CITY OF FREDERICKSBURG HISTORIC REVIEW BOARD

TUESDAY, SEPTEMBER 13, 2022

6. CERTIFICATE OF APPROPRIATENESS APPLICATIONS

EAST ELEVATION
SCALE: 1/4" = 1'

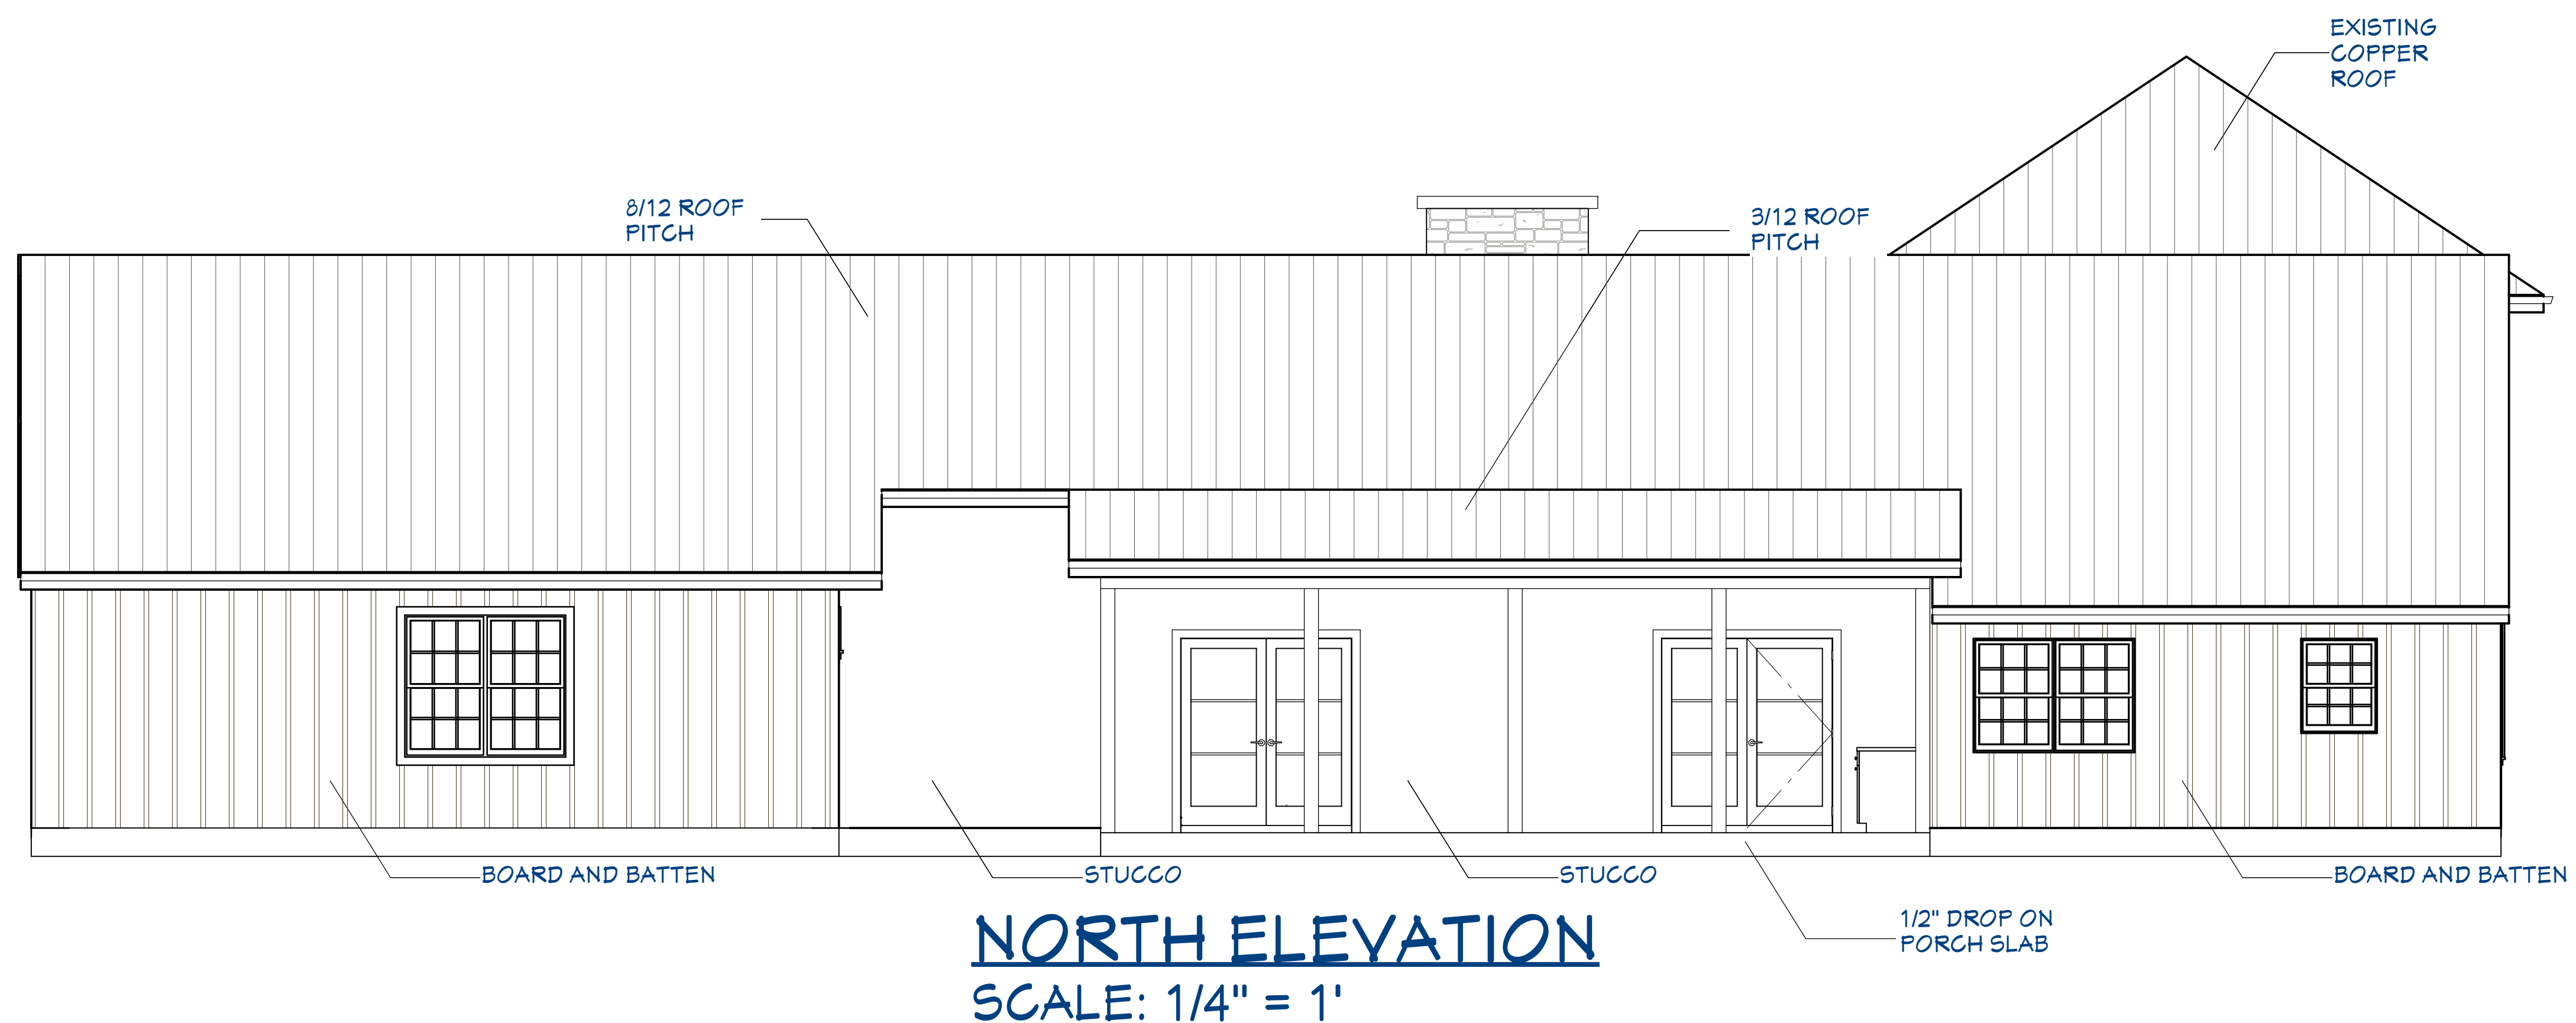
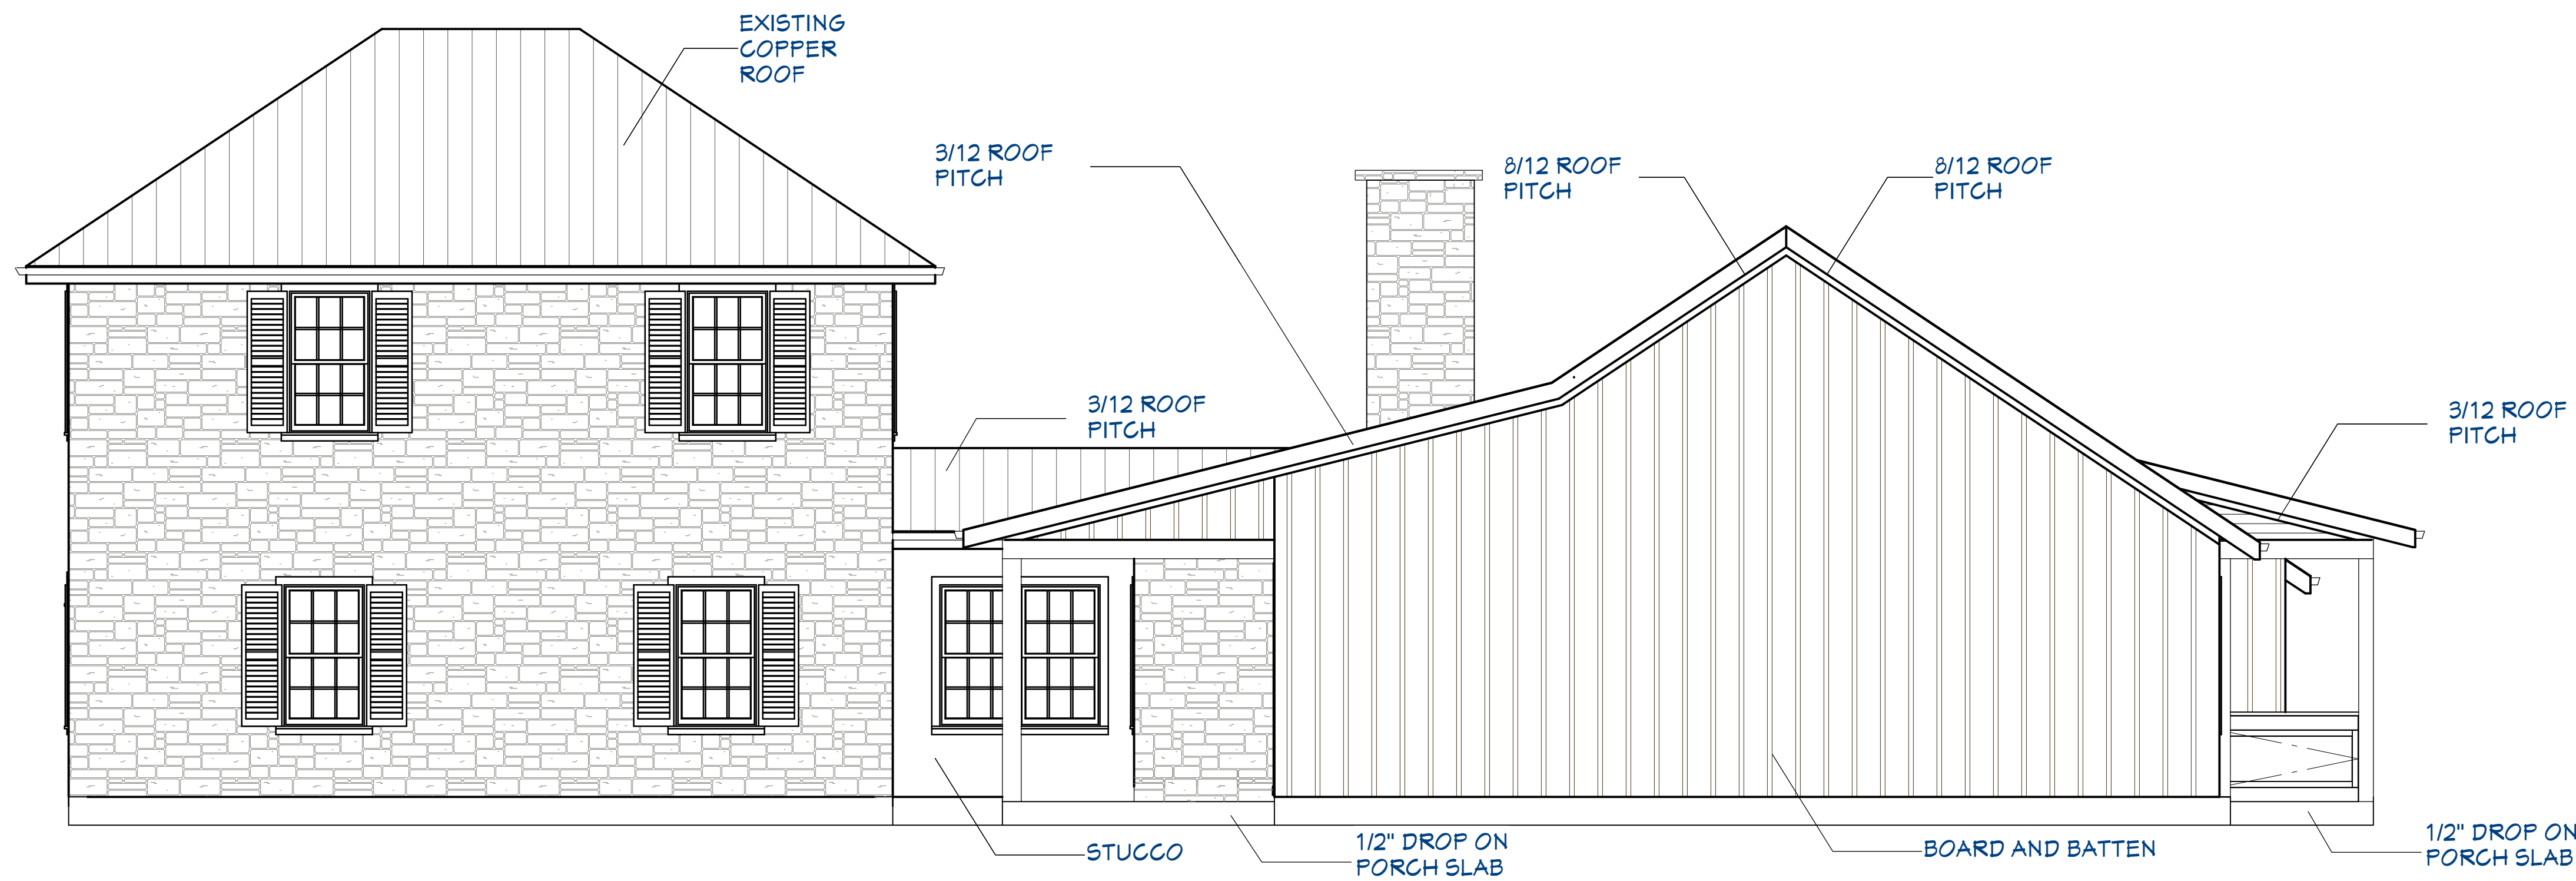
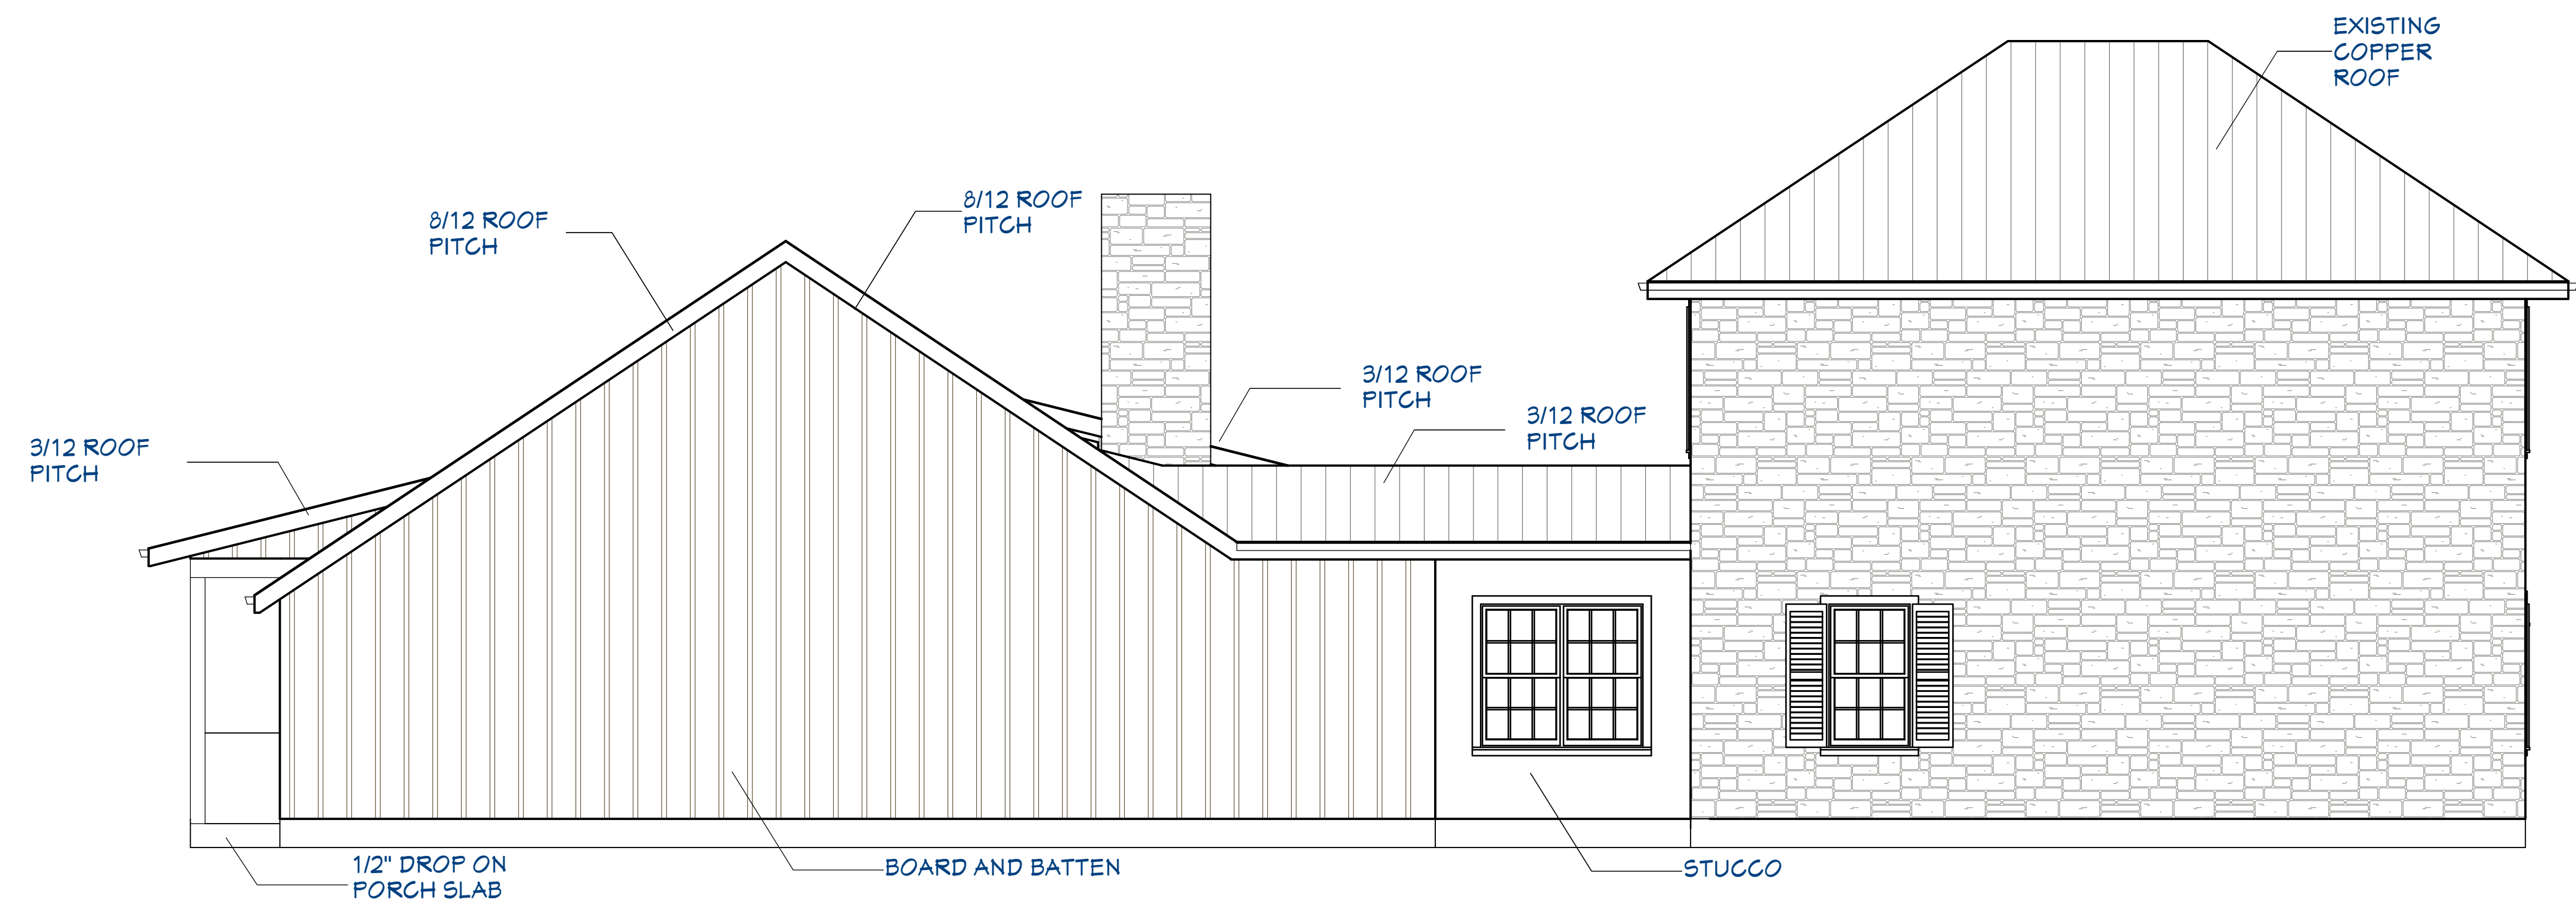
A. The 2012 addition will be removed and a new addition will include a new kitchen, dining, living, master bedroom suite and two porches. The new addition will be off set at the historic home with the main portion of the addition set back w/limited detail. The façade will include stucco/plaster finish, stone, and board and batten. The addition will have standing seam metal roof. The use of full glass doors will help break up the size of the new addition.
